Re: Proposed Gateway Pacific Terminal Project

The City of Mount Vernon ("the City") is closely following the Gateway Pacific Terminal (GPT) Project proposed by Pacific International Terminals, Inc., through SSA Marine which includes the development of a multi-user import and export marina terminal for bulk, break-bulk, and other marine cargoes and the Burlington Northern Santa Fe (BNSF) Railway's Custer Spur Rail Expansion project ("the GPT Project"). This letter is intended to serve as the City of Mount Vernon's scoping comments for the GPT Environmental Impact Statement and is submitted to you on behalf of the Mayor of the City of Mount Vernon and the Mount Vernon City Council.

Exhibit A

City of Mount Vernon Railroad Street Crossings

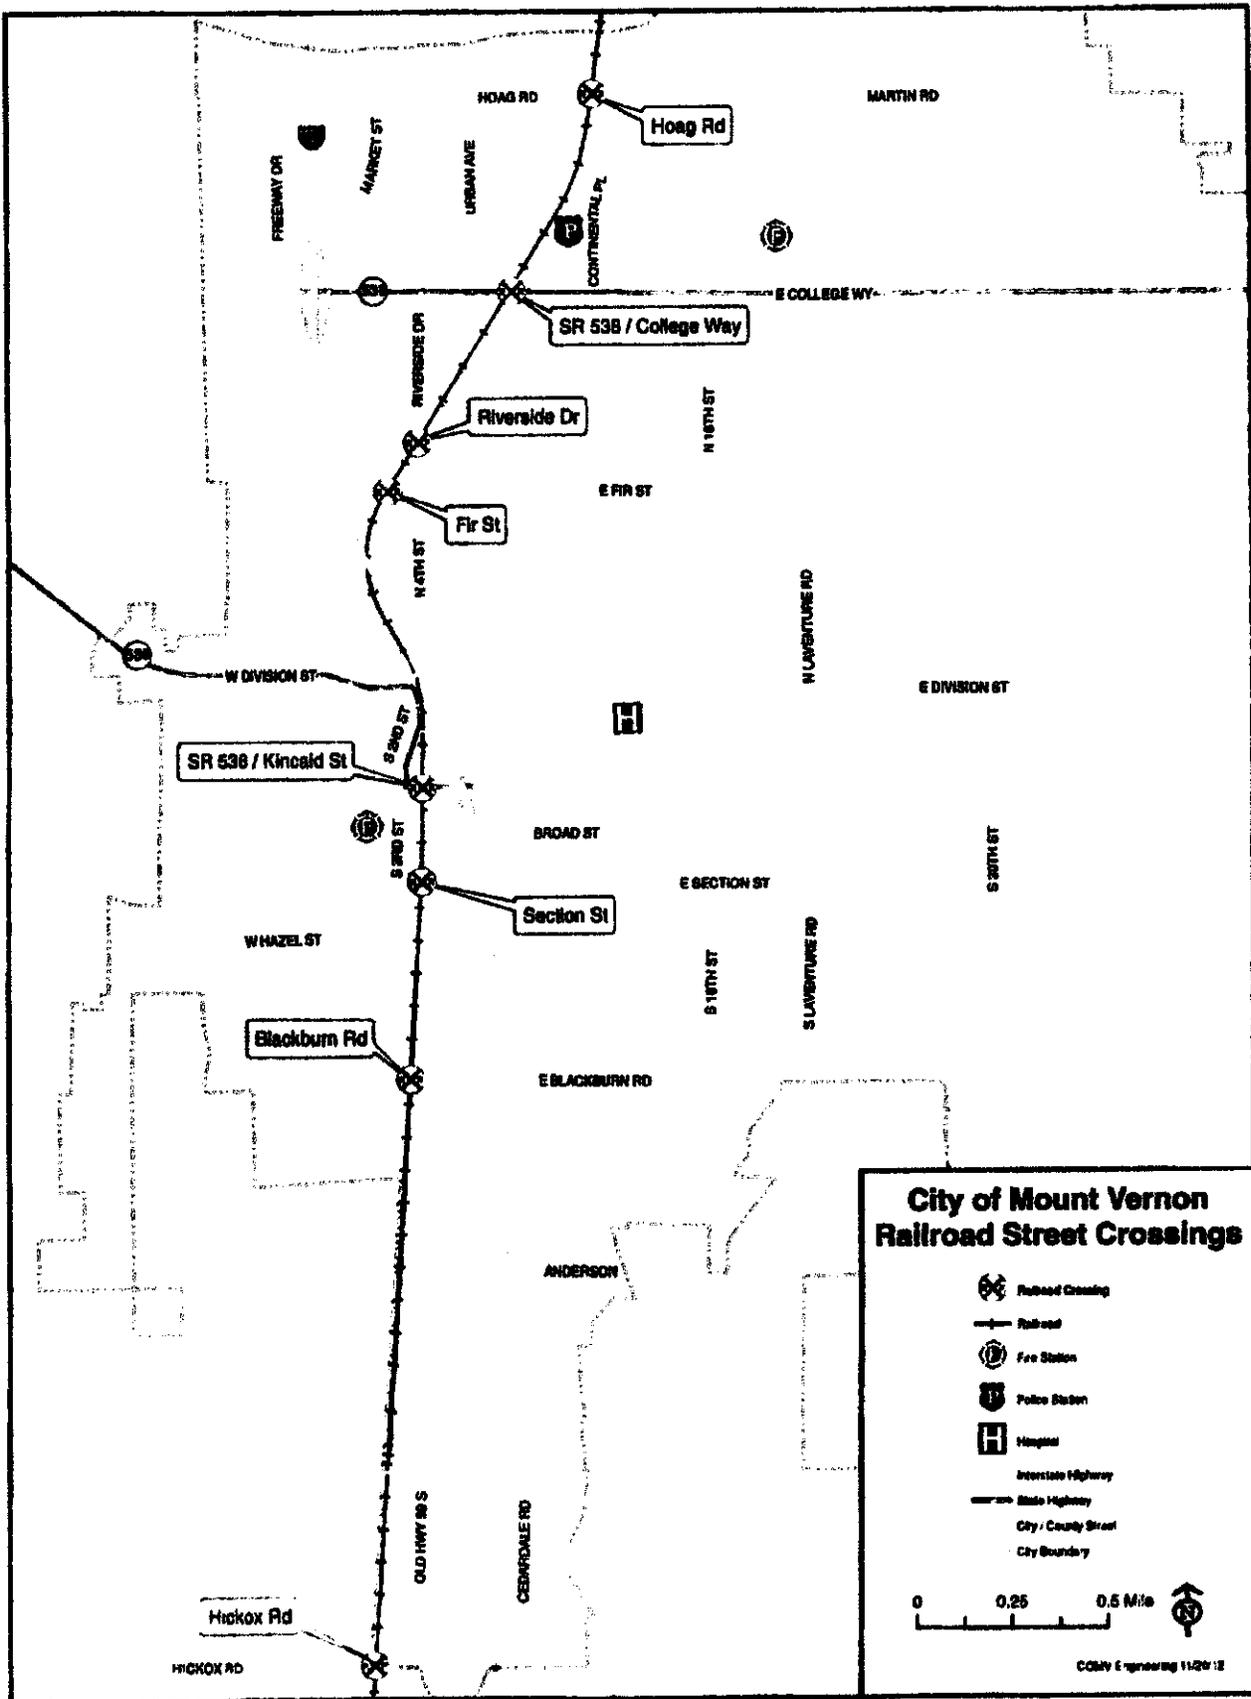
The City contains within its jurisdictional boundaries the BNSF rail line. This rail line has eight at-grade railroad crossings located within the City (two of which cross heavily traveled state routes; **Exhibit A**), one just east of College Way and Riverside Drive, the busiest intersection in the County, and another at Kincaid Street which is at the entrance to Mount Vernon's historic downtown and the location of the County Courthouse, Jail and City Hall. As explained below, it is expected this rail line, including at-grade crossings, will be utilized to serve the Project.

- A complete evaluation and potential mitigation of the transportation impacts to at-grade rail crossings including delays to traffic and emergency response time and impacts to passenger rail traffic at full build out. Reasonable alternatives such as separation of the grade crossing or relocation need to be thoroughly explored.

- *Please refer to Exhibit A for all at grade crossings to be examined for impacts and mitigation.*
